**BEFORE THE HEARINGS PANEL
FOR THE QUEENSTOWN LAKES PROPOSED DISTRICT PLAN**

IN THE MATTER of Hearing Stream 14:
Wakatipu Basin
hearing and
transferred Stage 1
submissions related to
Arrowtown and Lake
Hayes

**REBUTTAL EVIDENCE OF BRIDGET MARY GILBERT
ON BEHALF OF QUEENSTOWN LAKES DISTRICT COUNCIL**

LANDSCAPE

Figure 1: Proposed mapping amendment in relation to 76 Hunter Road.

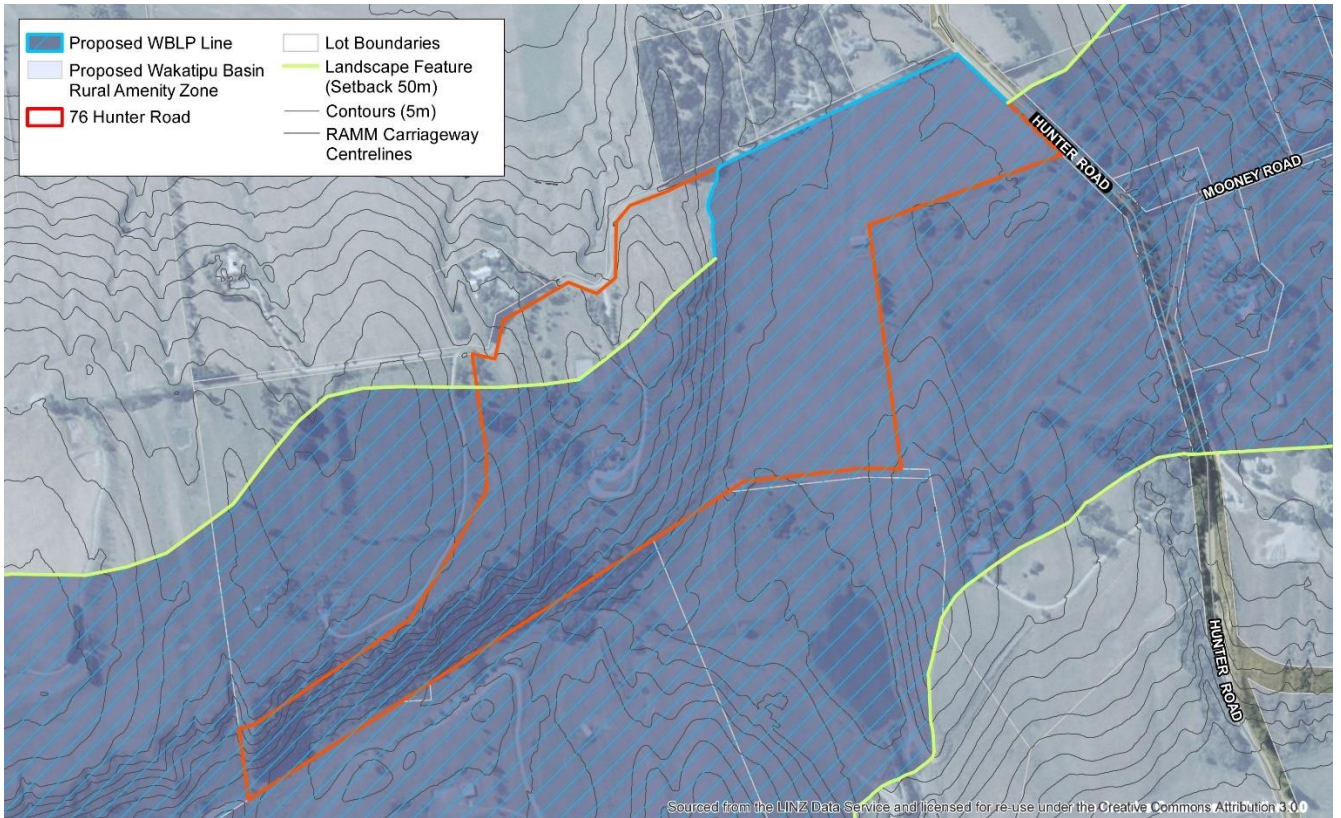
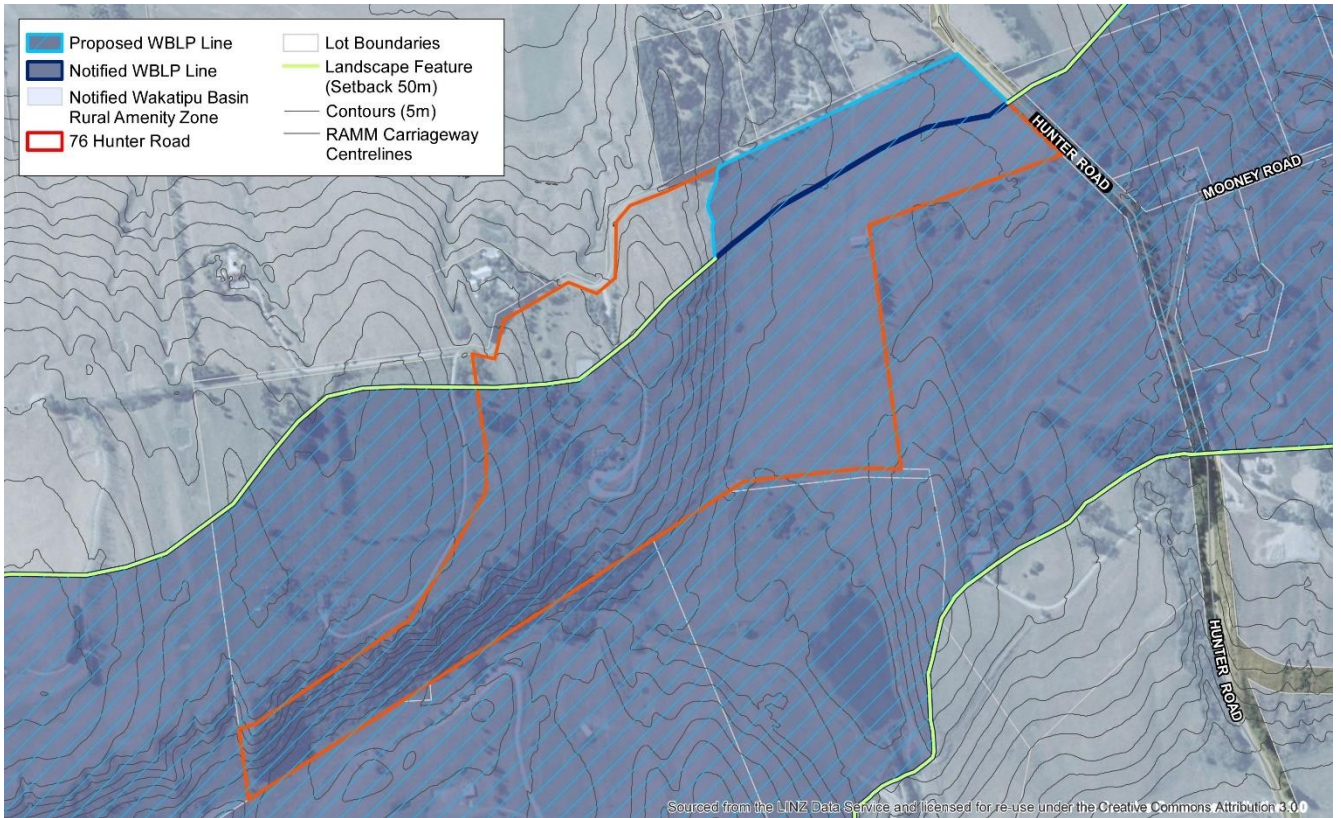
- 3.7** Unlike Mr Milne, I consider it necessary to retain the Precinct boundary along the crest of the ridgeline in the elevated central portion of the site to ensure that built development is not visible from the Malaghans Road valley. Were the Precinct boundary to correspond with the northern property boundary (in the manner recommended by Mr Milne), the Precinct and Landscape Feature line would be positioned up to 100m beyond the crest of the ridgeline, on the (downhill) Malaghans valley side, suggesting visibility from the Malaghans corridor and negating the mitigation benefits of the 50m Landscape Feature Setback. I consider such an outcome to be inappropriate given the Very Low absorption capability rating of LCU 1 Malaghans Valley (and despite the landscape driven Precinct assessment criteria).

- 3.8** The extent of the Precinct boundary realignment and Landscape feature line amendment that I support at 76 Hunter Road is depicted below in **Figure 1** and **Figure 2**.

Figure 3: Tucker Beach Structure Plan. Yellow shaded areas correspond to the TB Precinct areas. Pink shaded areas correspond to the Precinct areas. Blue hatched areas correspond to the Escarpment Protection Area. (Source: B Espie EiC.)

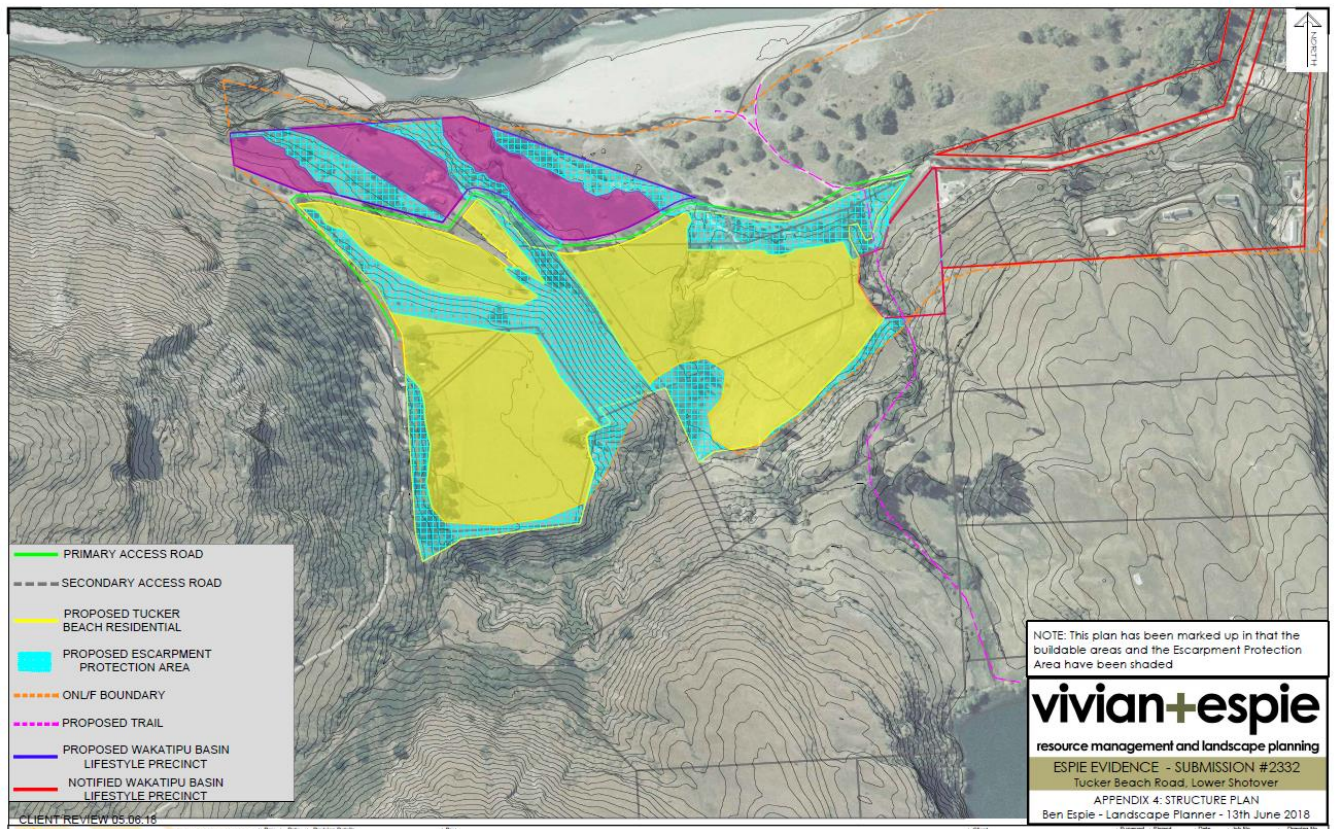
4.10 I also agree that the confinement of TB Precinct to the flat river terrace areas is sympathetic to the intentions of avoiding adverse effects on the adjacent ONL (and the landscape generally), and that the marked change in landform pattern coinciding boundary of the structure plan area goes an appreciable way to establishing a clearly legible and defensible edge.

4.11 Nonetheless, were the Panel minded to approve the TBSP, it is my recommendation that the landscape buffer associated with the proposed EPA is extended along the western and southern edges of the TBSP area (and the provisions modified) to ensure a continuous landscape buffer (minimum width 20m) incorporating a cohesive large-scale planting strategy to the ONL edges of the TB Precinct. I agree with Mr Espie that there are many instances in the District where urban development is inevitably 'hard up' against ONLs; however, it is my view that where the opportunity exists to augment such edges by way of a vegetated landscape buffer, it should be utilised as it enables a more sympathetic transition between the contrasting land uses (and landscape characters). In my opinion, the greenfield development at the boundary of the TBSP area presents such an opportunity.

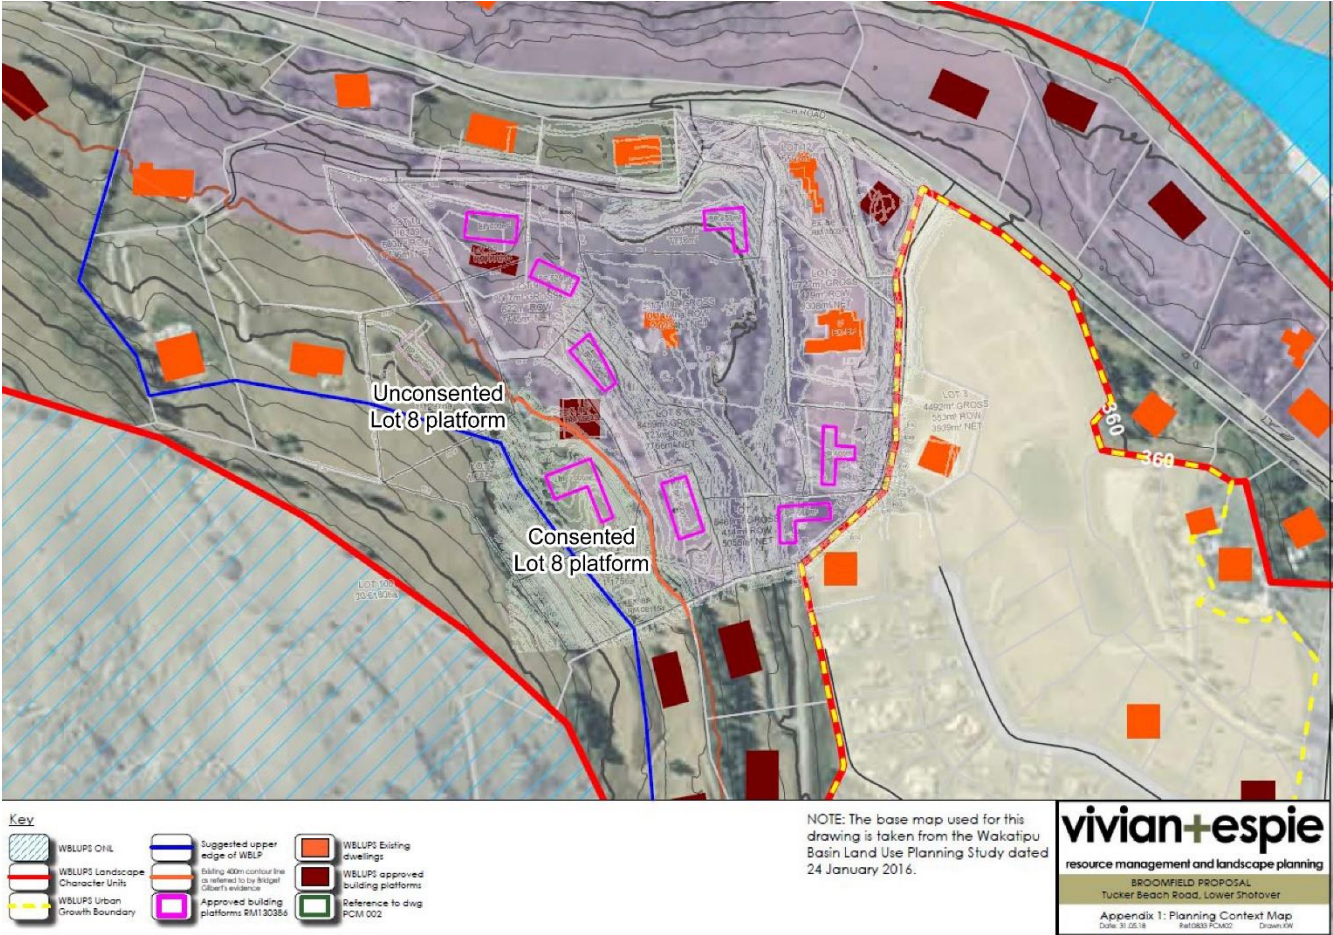
- 5.9** In this instance, there is no easy solution with respect to the delineation of the Precinct, as there are no clear geomorphological features evident. Reliance on a contour line at least provides plan users with a definite location for the Precinct boundary (noting that the LiDAR source contour data relied on to determine the Precinct boundary is accurate within + or - 0.25m).

- 5.10** In my opinion, Mr Vivian’s approach of configuring the Precinct boundary to ‘capture’ the consented development on the submitter’s land and neighbouring properties is more arbitrary in comparison to the contour line method and would be extremely difficult to administer ‘on the ground’. (By way of explanation, a hand held GPS unit could

Figure 5: Unconsented Lot 8 platform and consented Lot 7 platform (Source: C Vivian EIC.)

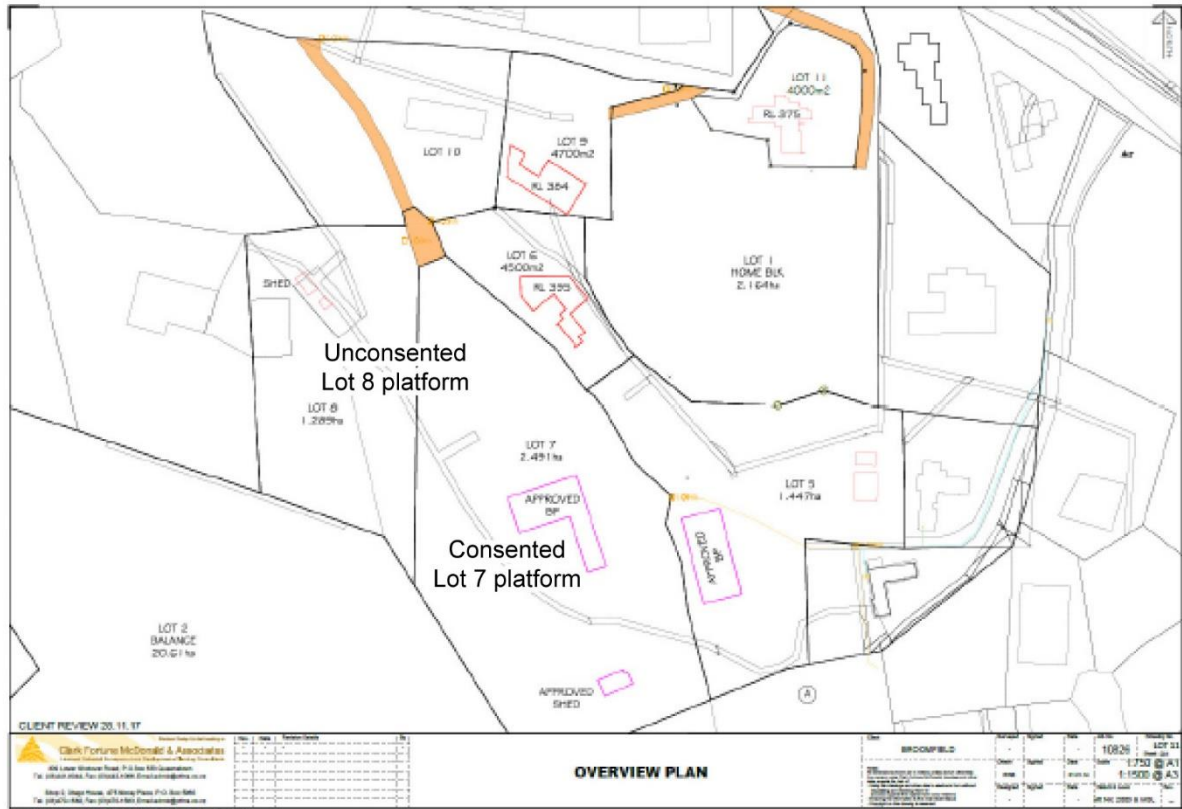
- 5.4 I have reviewed the Decision in relation to the approved 8 lot rural residential development (RM 130386) on the property, referred to by Mr Vivian.
- 5.5 I note that both Lots 7 and 8 on **Figure 4** are located above the 400m contour line.
- 5.6 It is my understanding that Lot 8 was deleted from the approved subdivision layout on the basis of adverse landscape and visual effects¹⁵ and that the generous scale of approved Lot 7 (which incorporated the 'deleted' Lot 8) was considered to be necessary to manage the effects of the development. The following extract from the RM130386 Decision provides context in this regard:

Figure 7: 'New' Precinct area recommended by Mr Baxter shown as blue horizontal hatch. (Source: P Baxter EIC.)

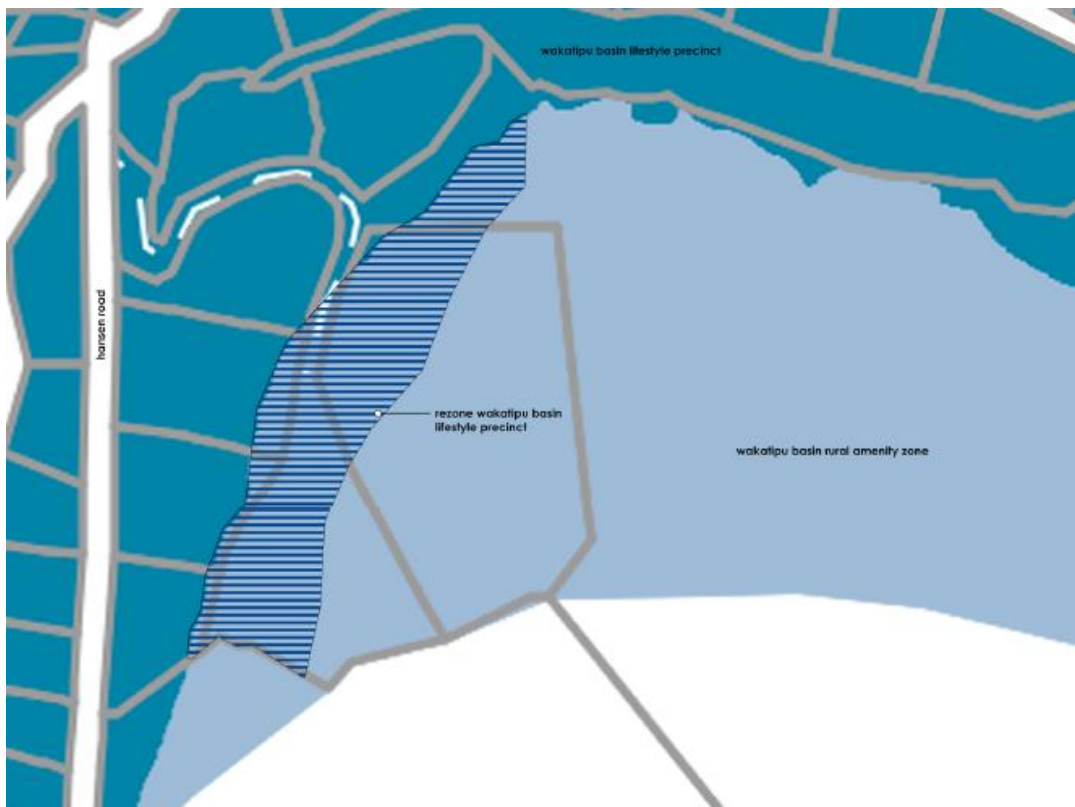
- 6.4** The analysis provided by Mr Baxter amounts to an evaluation of the two platforms (assuming his location-specific development controls) rather than an analysis as to why he considers the Precinct is more appropriate in this location from a landscape perspective. As such, I consider his evidence to be more suited to a resource consent application rather than a plan change.

Figure 8: Location of the Donaldson Block adjacent Millbrook complete with road connections. (For mapping legend refer my EiC Annexure 5.)

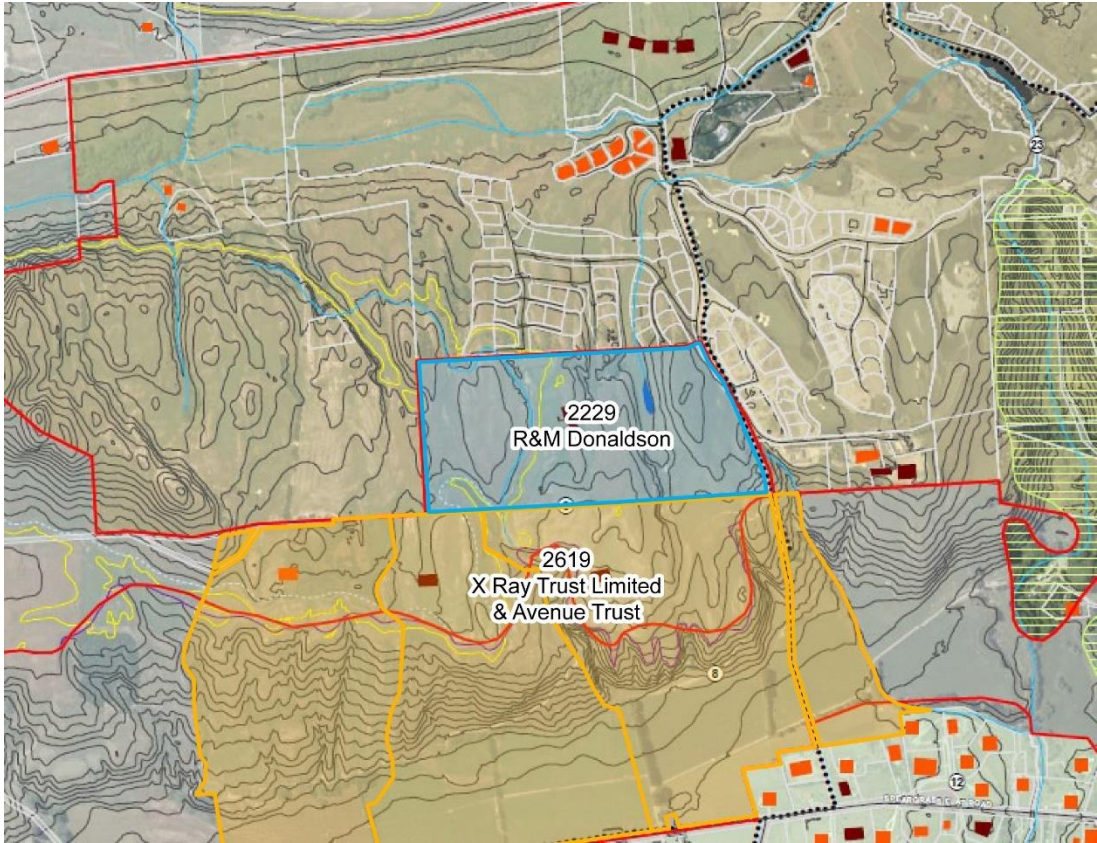
- (a) the two very large rural residential dwellings that have been consented on the Plateau, with generous manicured curtilages and extensive amenity plantings as depicted by Figure 28 in my evidence in chief (page 71)¹⁹; and
- (b) the urban development within Millbrook on elevated land adjoining and 'at grade with' the Donaldson block. **Figure 8** below demonstrates this spatial relationship.²⁰

- 7.8** I also do not share the same concerns as Mr Blakely with respect to the importance of the eastern end of LCU 6 as a foil to Millbrook in views from the surrounding area.

Figure 9: 'New' Precinct area recommended by Mr Skelton depicted in light blue and blue green toning to left of graphic. (Source: S Skelton EIC).

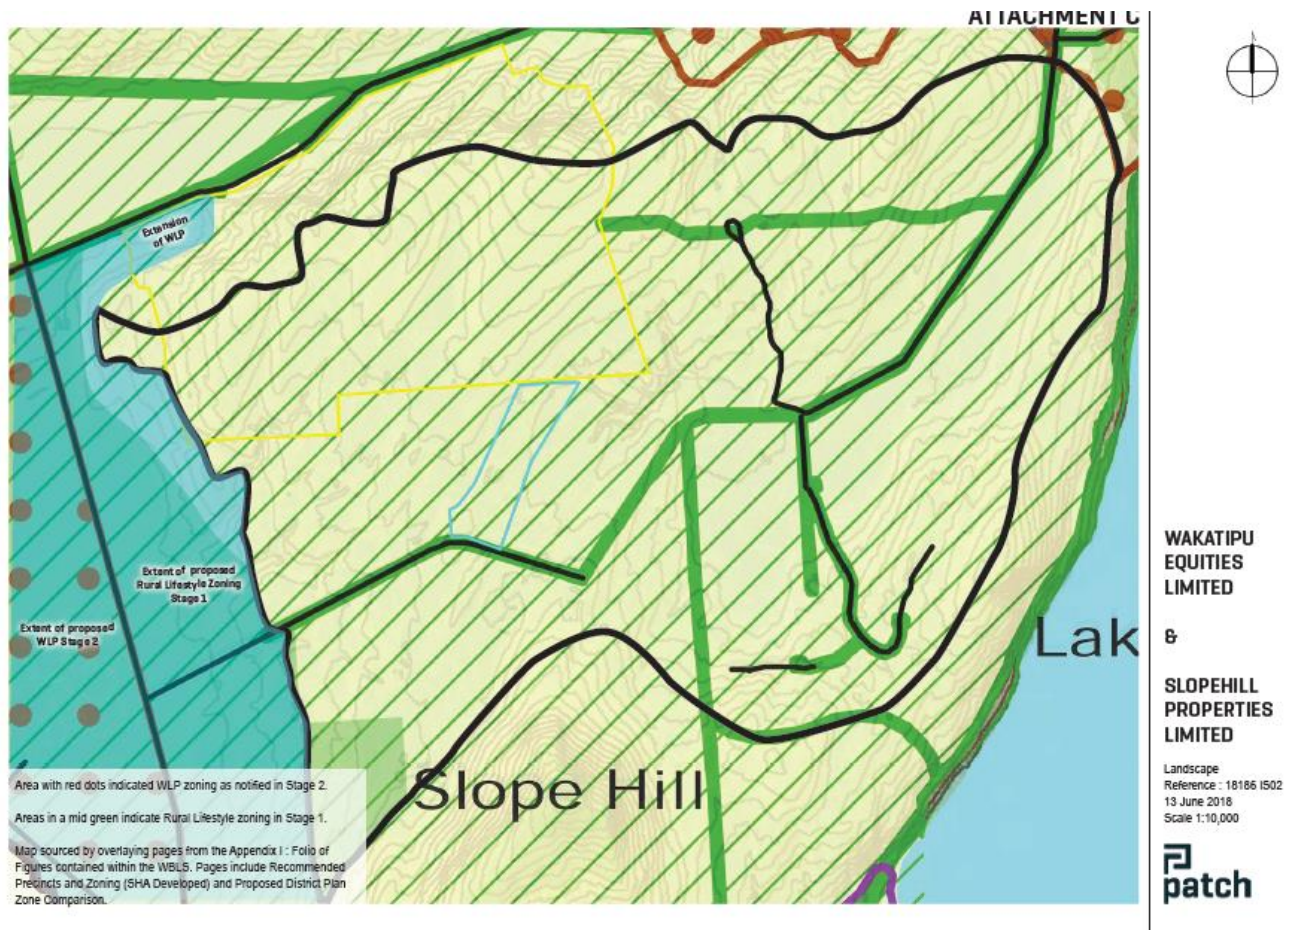
- 8.3** Mr Skelton does not appear to support the Precinct on the steep north-facing hillslopes within the WEL property, consistent with my evidence in chief.
- 8.4** Fundamental to Mr Skelton's analysis that the above described areas are suited to be zoned as Precinct is his interpretation that they form part of LCU 9 Hawthorn Triangle as a consequence of the existing level of rural residential development evident.²² Mr Skelton goes on to argue that the geomorphological boundary coinciding with his new extent of LCU 9 makes his 'new' Precinct area suited to successfully absorbing additional development.²³

Figure 10: LCU 9 Hawthorn Triangle. Mr Skelton's LCU 9 'extension area' relates to the land on the east side of Lower Shotover Road. (For mapping legend, refer my EiC Annexure 5.)

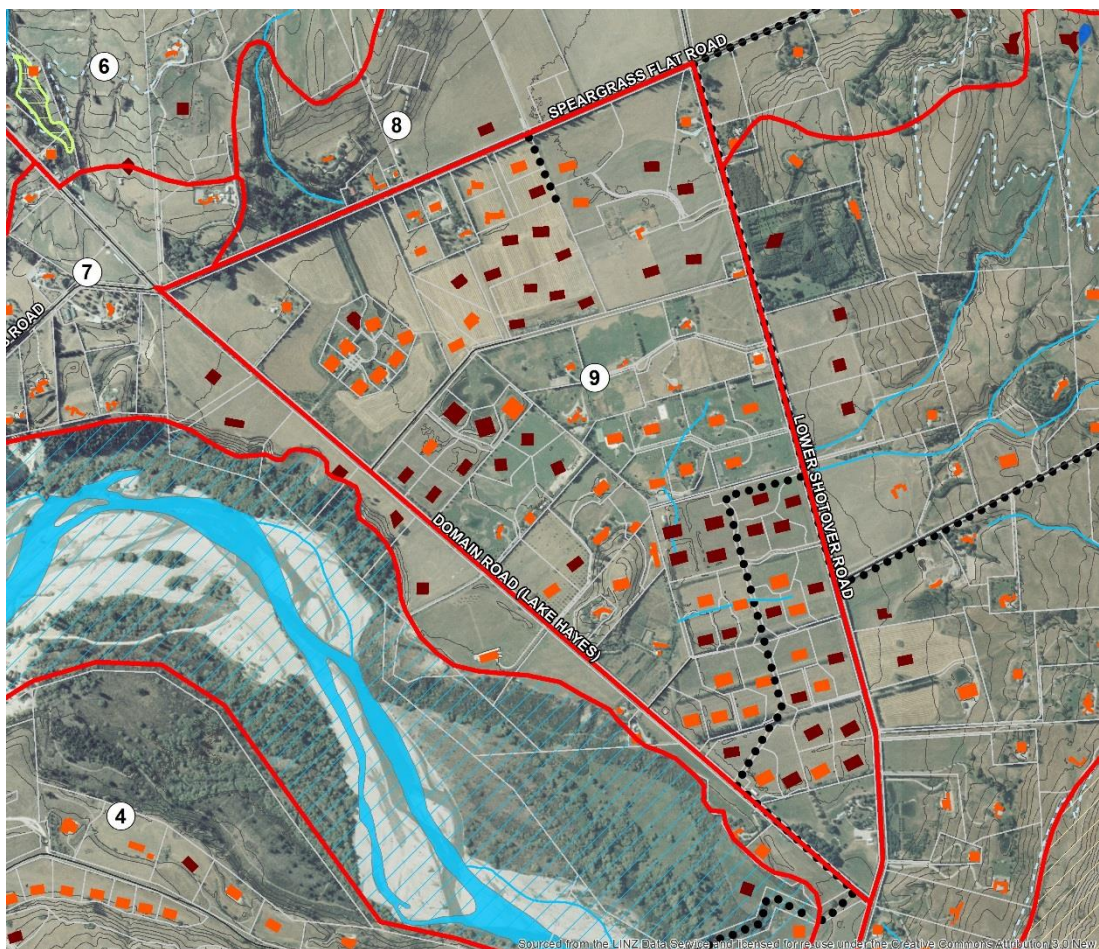
- (b) I consider the dense patterning, density and character of rural residential within LCU 9 Hawthorn Triangle (described as a large lot suburban parkland character in Schedule 24.8 under 'Sense of Place') to be markedly different to the considerably more spacious and vegetated rural residential patterning evident in Mr Skelton's LCU 9 'extension area'. **Figure 10** below illustrates this variance in patterning.

- 8.6** As a consequence, I consider it somewhat spurious to include the flat WEL land adjacent Speargrass Flat Road and the land on the east side of Lower Shotover Road within LCU 9.
